RE: **Approval of Site Plan # 18-018654**– Carver Auto Sales Paving Project for the auto sales area at 1328 Point Douglas Rd. – Site Plans prepared by Loucks Associates with revisions through 07/03/2018.

Site Plan Review Report

SPR File # 18-018654

Project: Carver Auto Sales

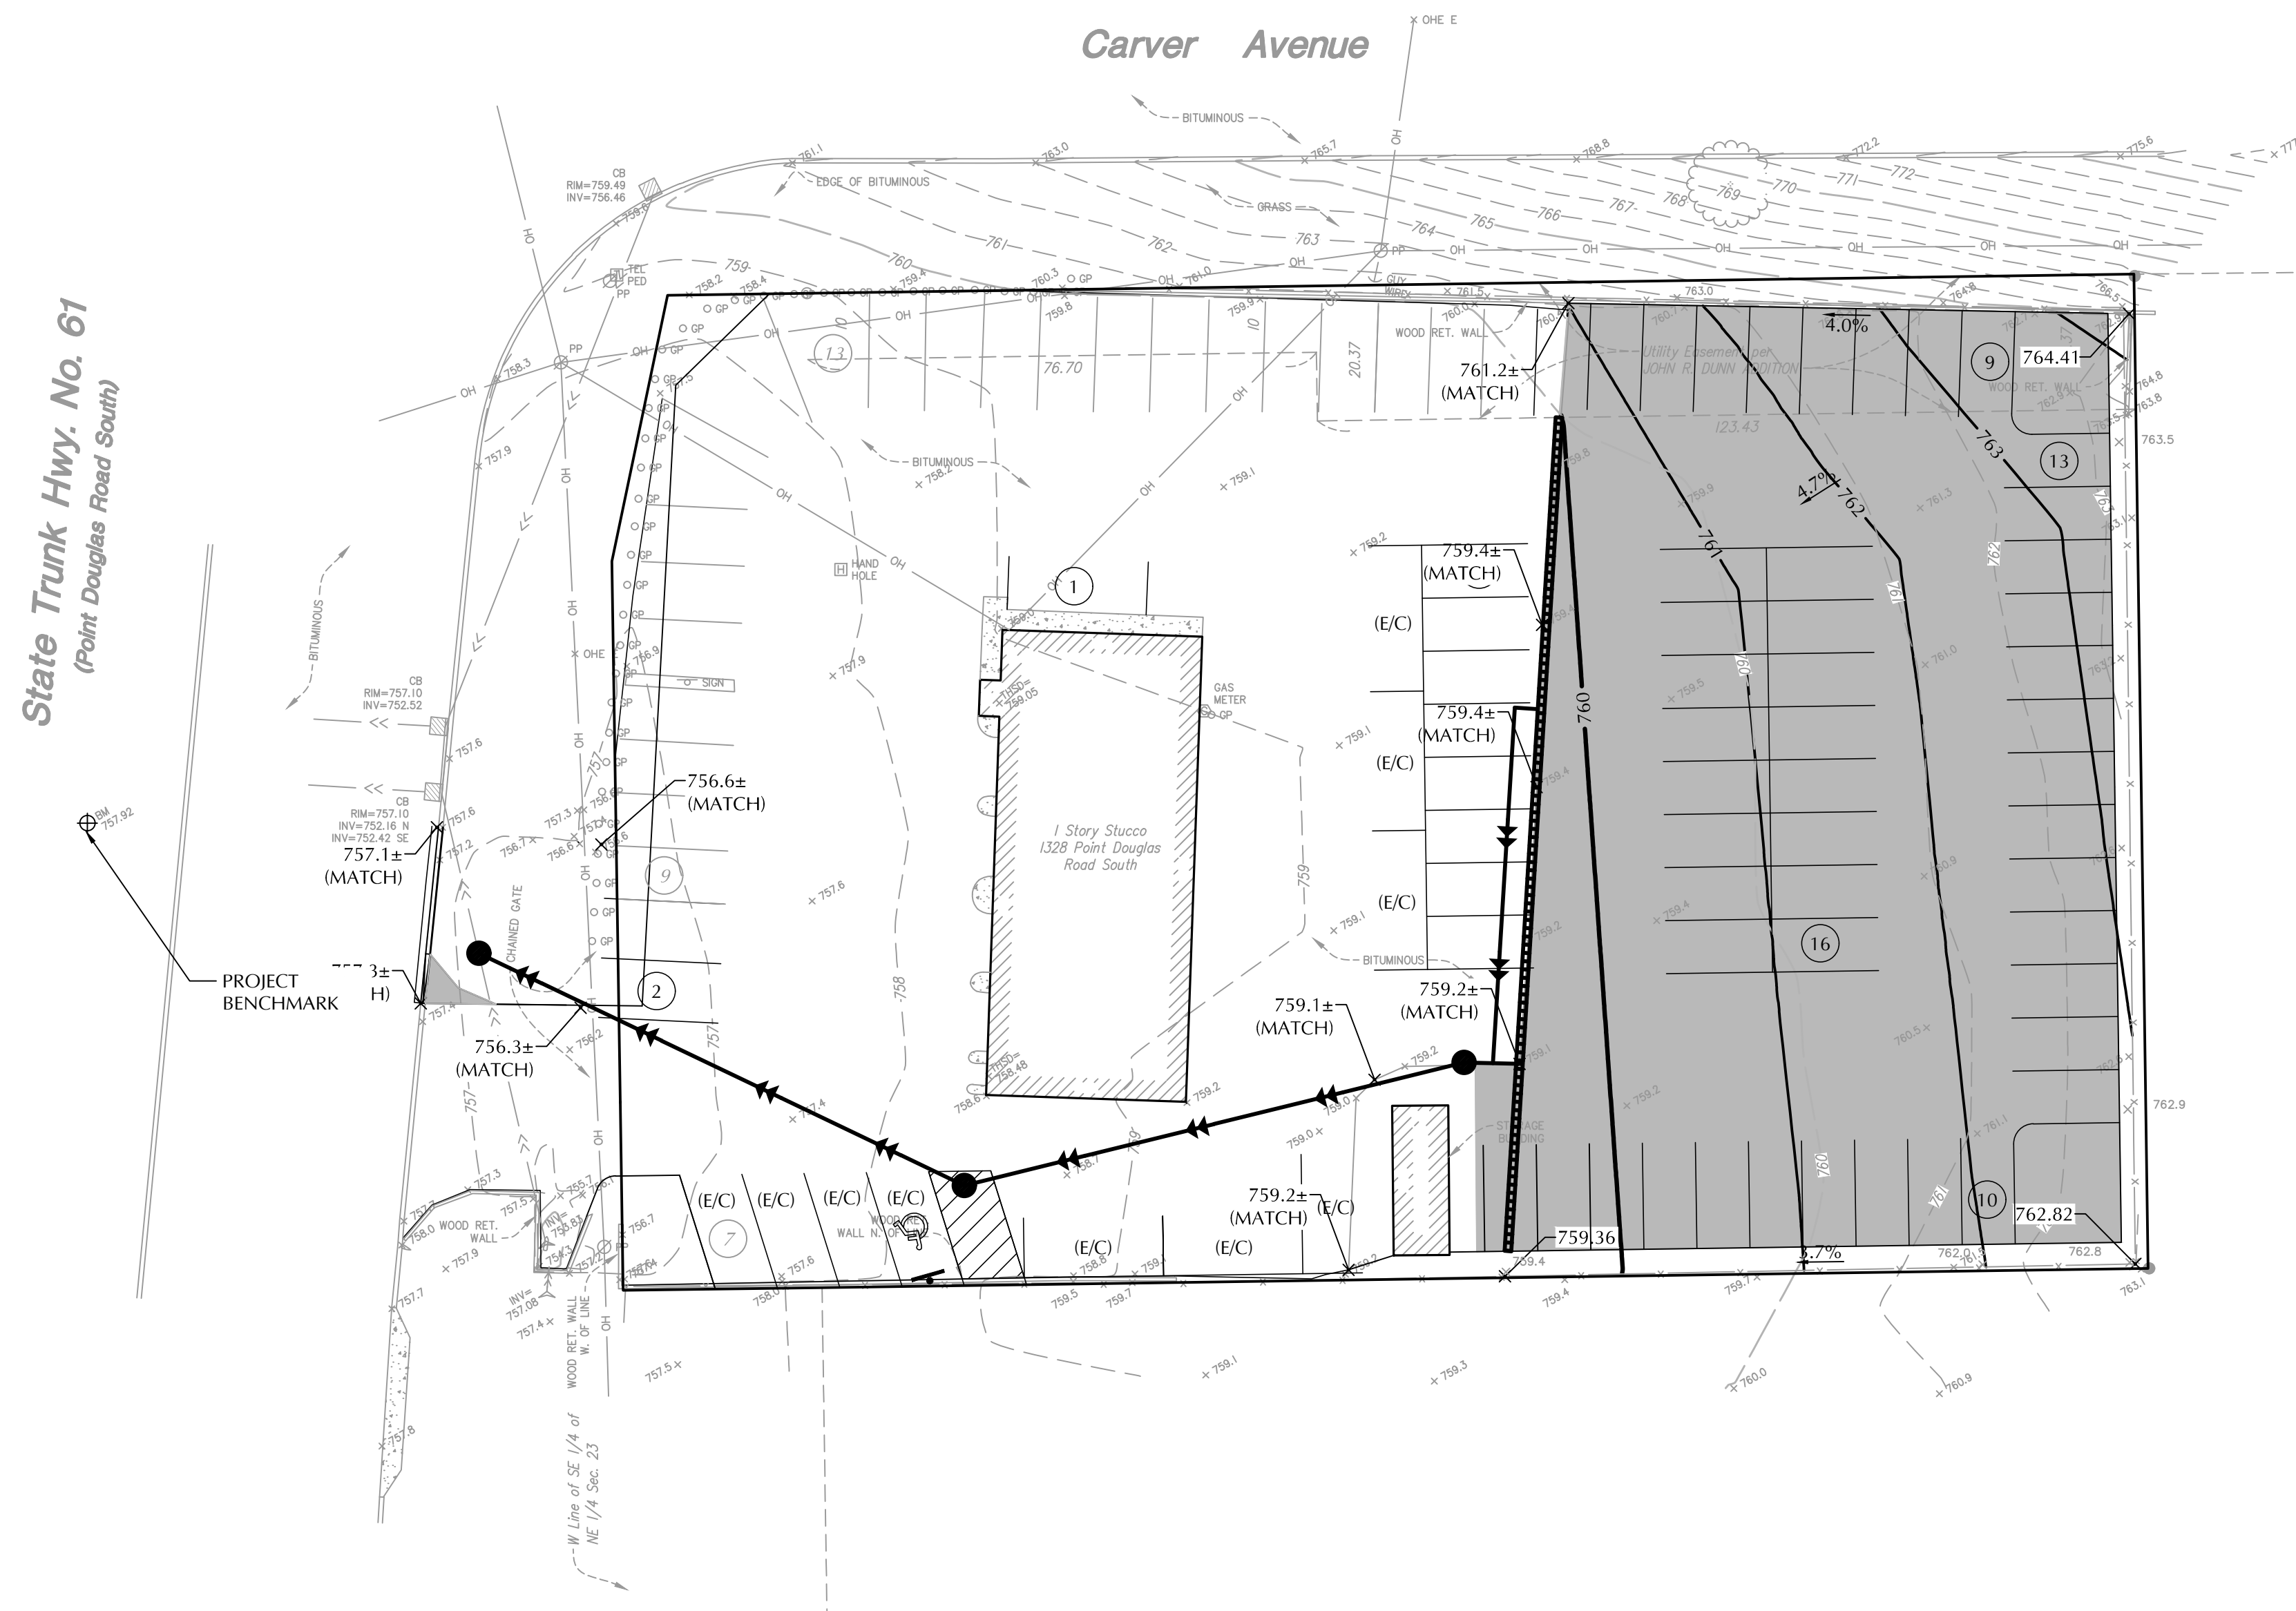
- On the Boundary & Topographic Survey plan sheet, please include the document reference number for the vacation of Hastings Avenue.
- On Plan Sheet C1-2, please indicate that any existing posts that are in the right-of-way (ROW) are to be removed and the area restored. As shown on the plans, only posts in the driveway are identified as being removed and asphalt repaired.

- The project is located within the Tree Preservation Overlay District, city ordinance 67.200. A tree preservation plan is required. Please update the survey to show all trees located on this property including species and trunk DBH (diameter 4.5ft above grade).

- Indicate trees that will be removed or trees to be protected on the plan.
- Preservation and replacement tree planting requirements will be reviewed according to city ordinance 67.200.

**C3-1**

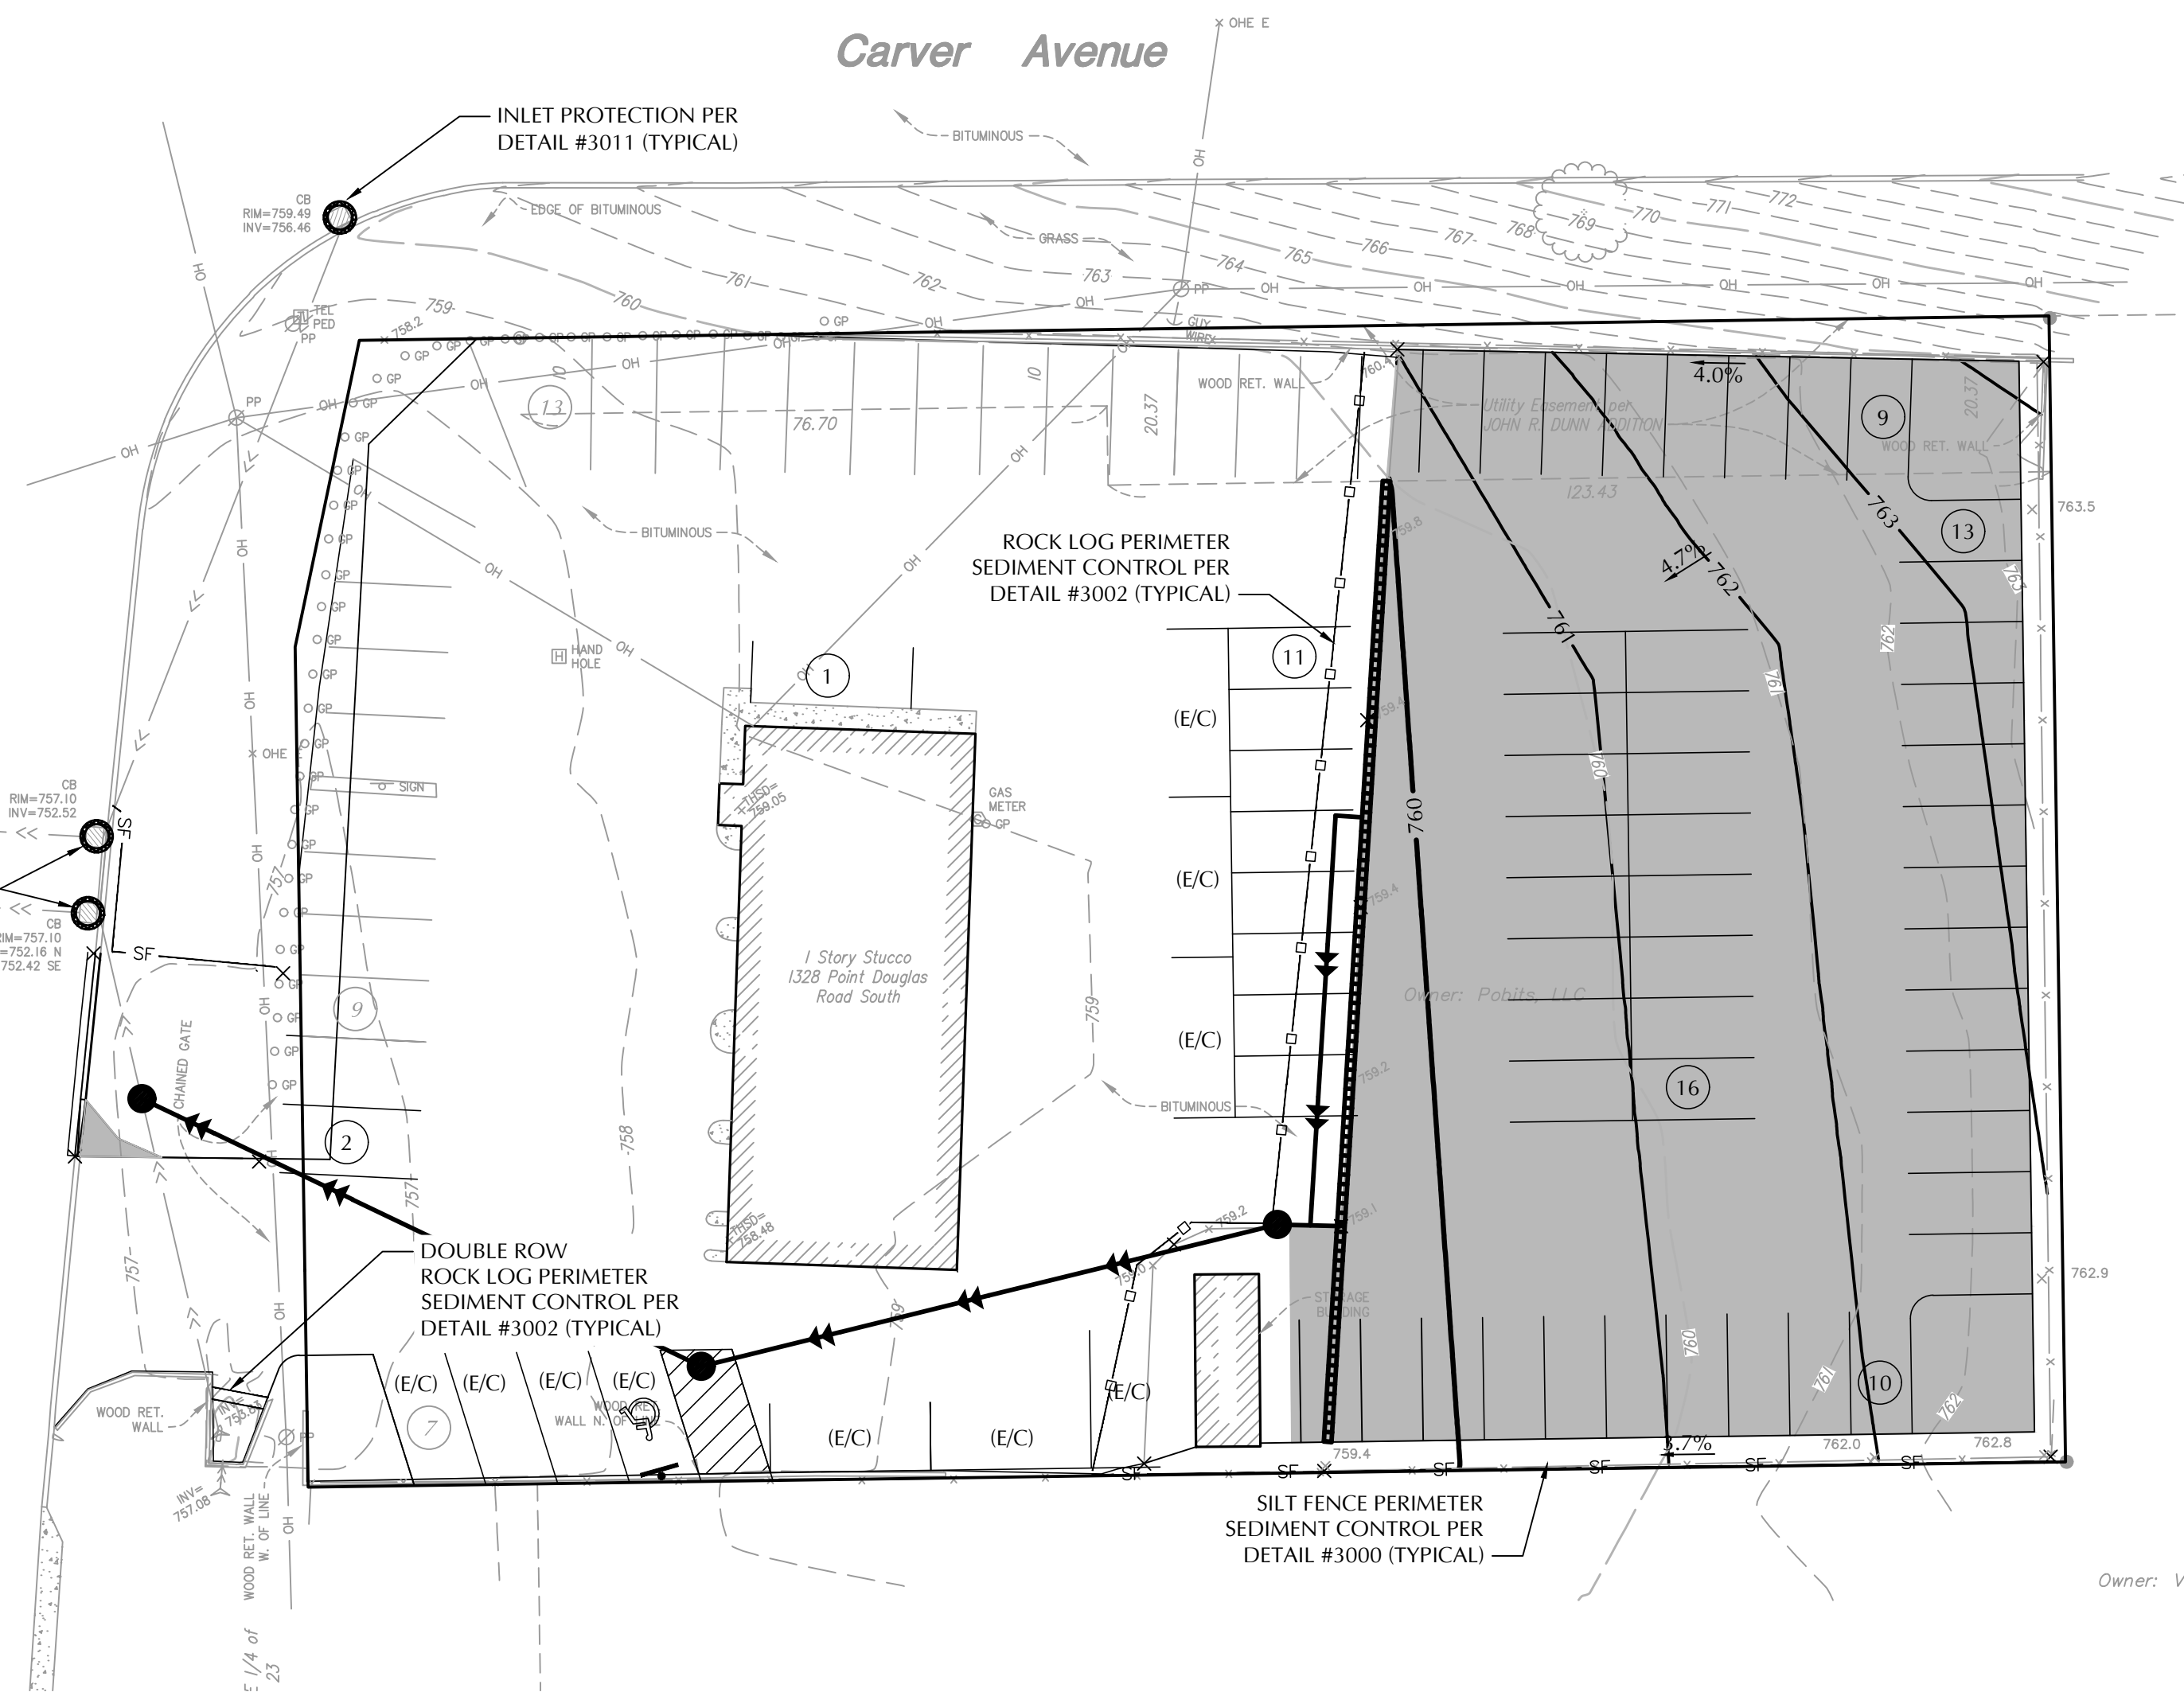
Provide the following on PLAN SHEET C3.1 under NOTES:

- Maintain 8 feet of cover over all water mains and services.
- All water service valve boxes within construction area must be exposed and brought to grade upon completion of construction.
